FINAL-MY2 Monitoring Report

Seniard Creek Mitigation Site

NCDMS Project No. 100017

Subject: Draft MY2 Monitoring Report
Seniard Creek Site, Henderson County
French Broad River CU 06010105
DMS Project ID No. 100017 / DEQ Contract #7189

Replanted Areas MY2
Seniard Creek
Stream Restoration Site
Henderson Co., NC

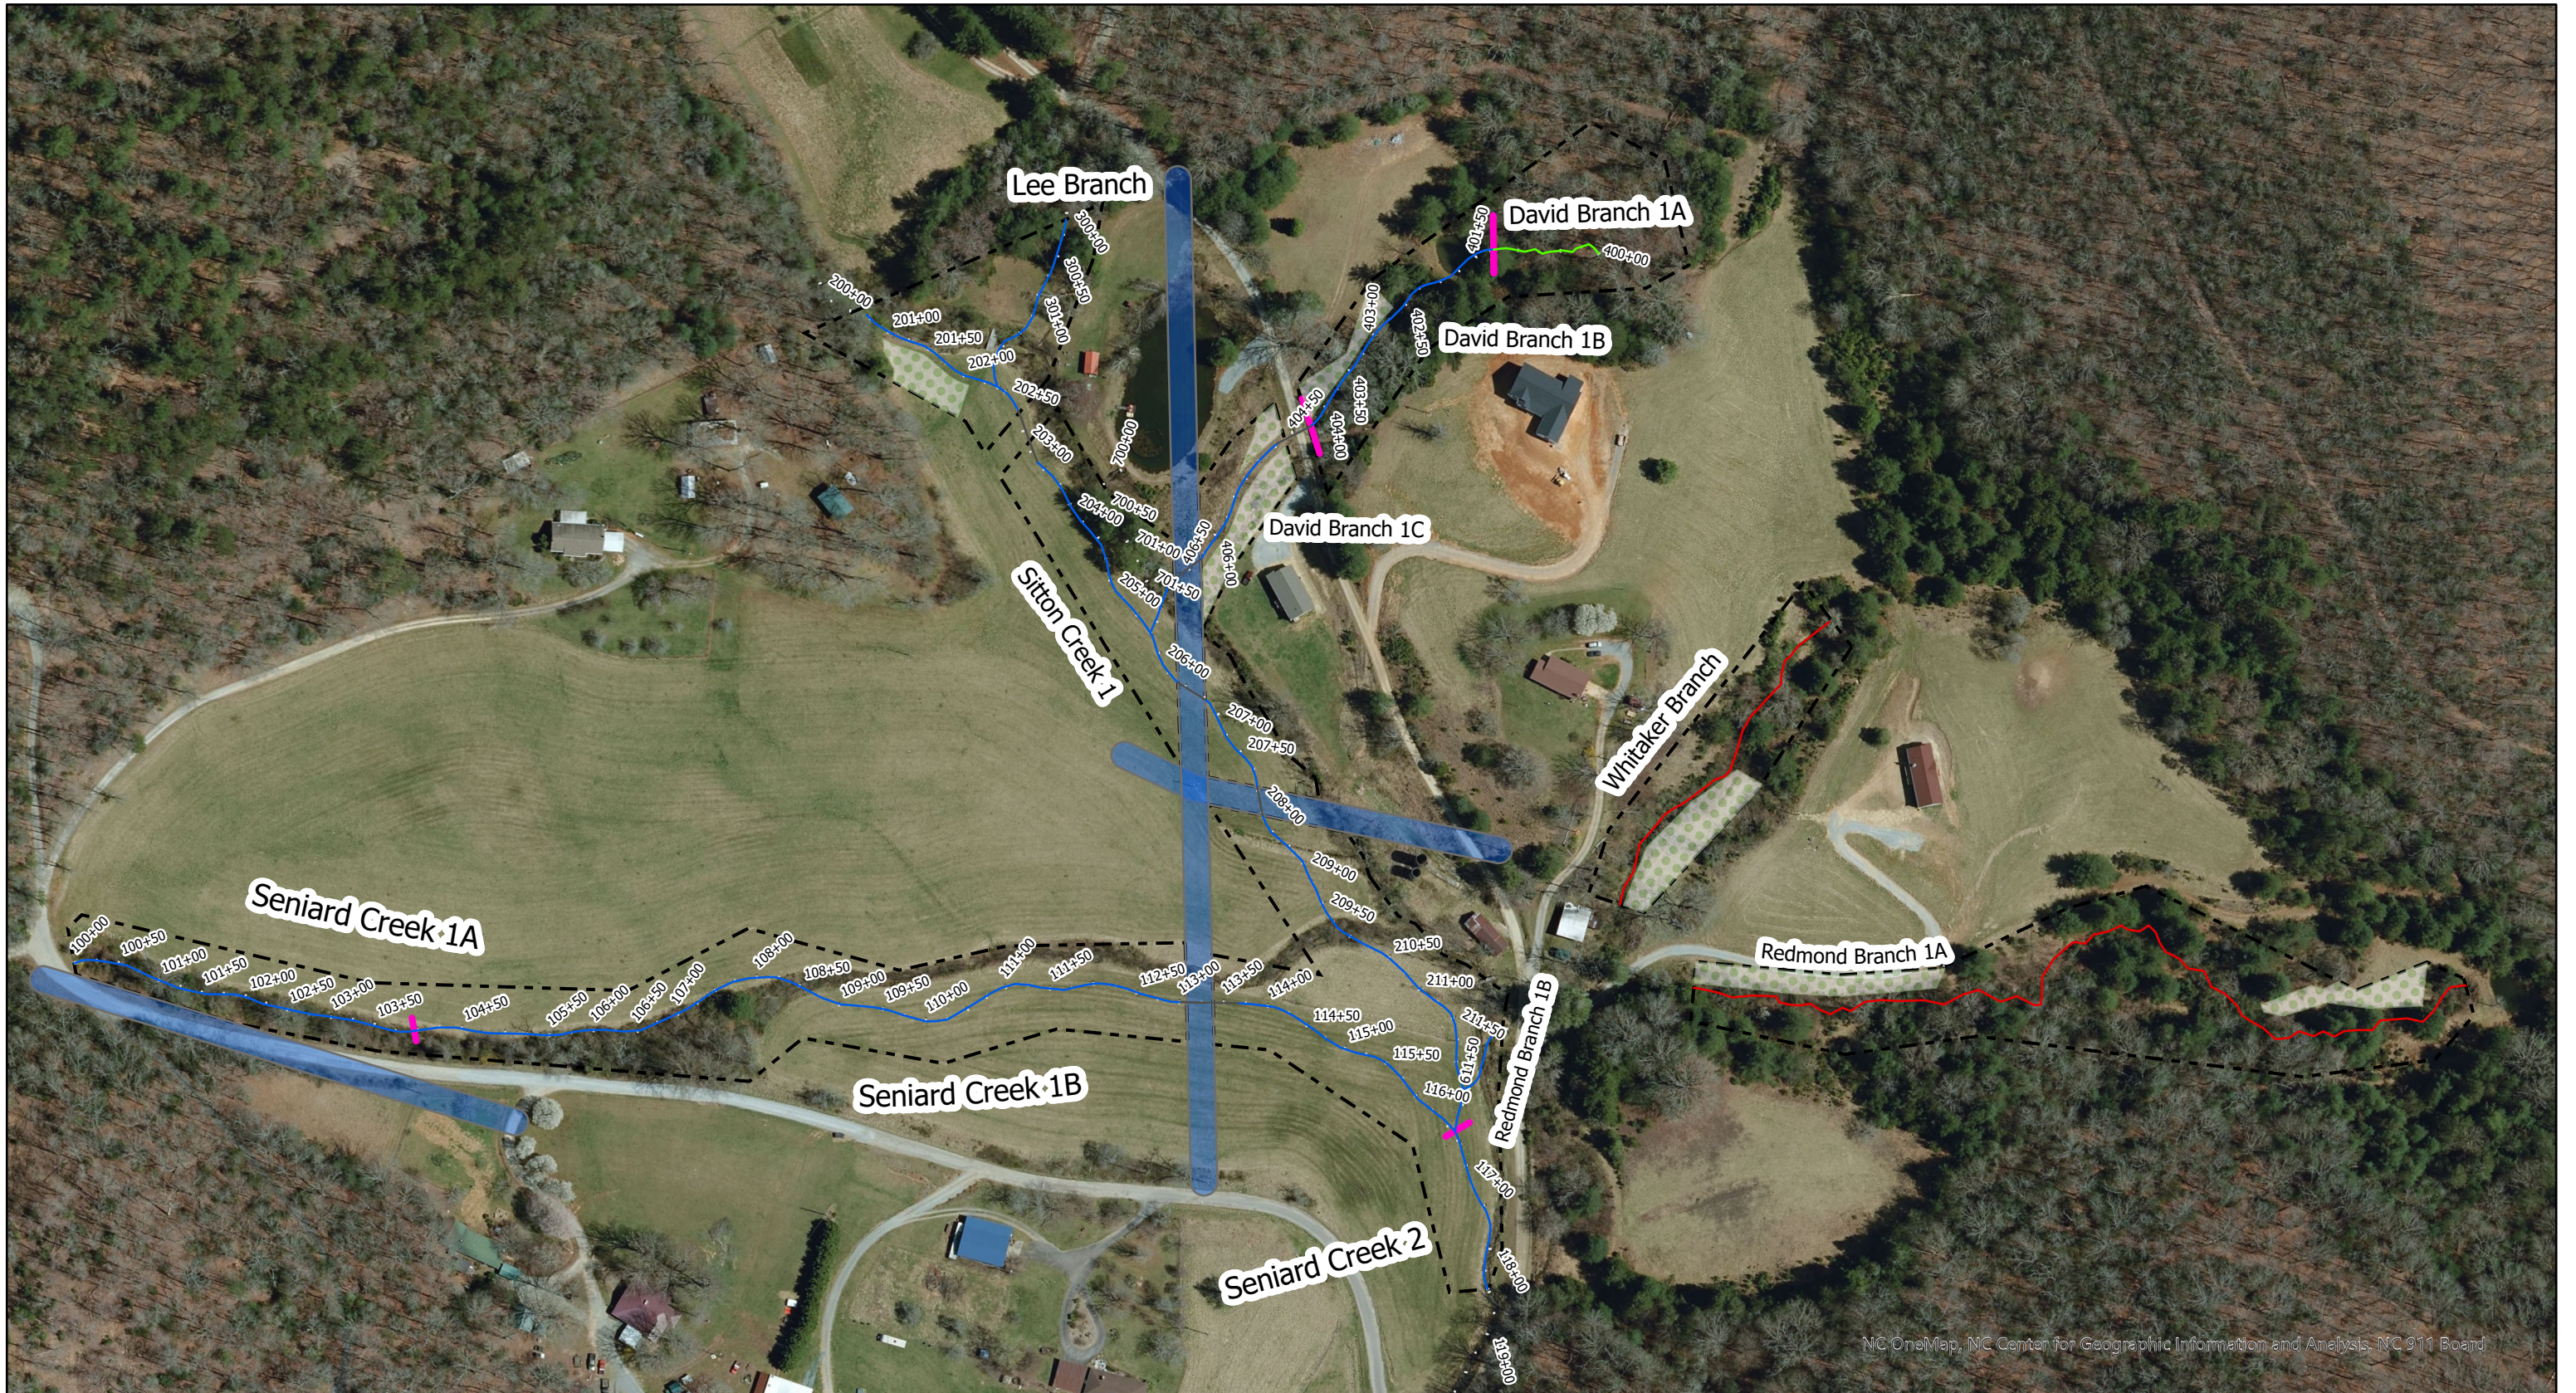
- Supplemental Planting has been mapped on the CCPVs and the plant list is included in Appendix F; please also indicate whether or not the species planted are all from the IRT-approved mitigation plan. **Species were selected based on the IRT approved plan.**

- The supplemental planting quantities are not listed. Can EWS provide a planting area and quantities of each species? This would be helpful to know a) the area across the site that got planted relative to the total planted area, and b) an idea of the proportional amounts of each species (e.g., that it wasn't 90% one species and 10% all the rest). **The supplemental planting was conducted following identification and flagging of existing stems. The planting re-established an approximate 6' center of woody stems in encroachment and low stem density areas. A bulk order was placed for use in numerous projects. As such, EWS is unable to provide a specific number of stems planted at the Seniard Project but can provide an approximate species distribution of approved species based upon that bulk order.**
